Part Change Notice

Re: Kycon PN: STX-3000

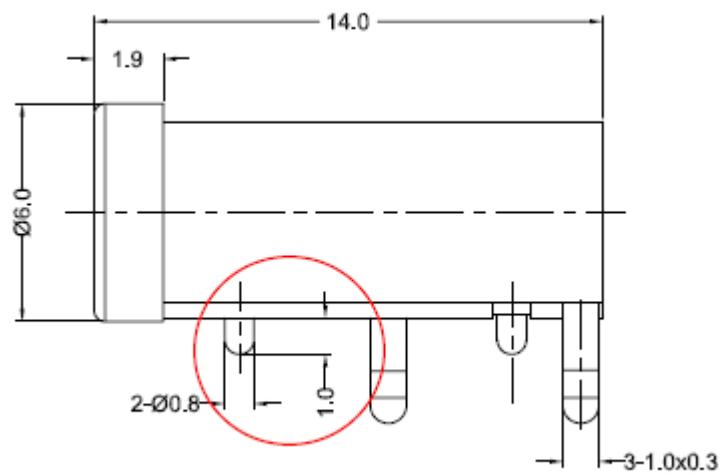
Kycon has made an improvement to part number STX-3000. The peg lengths have changed from 1.8mm to 1.0mm. This will help to insure that pegs do not get damaged during shipping while still providing customers with the added strength the peg provides.

Please see below for pictures of the difference.
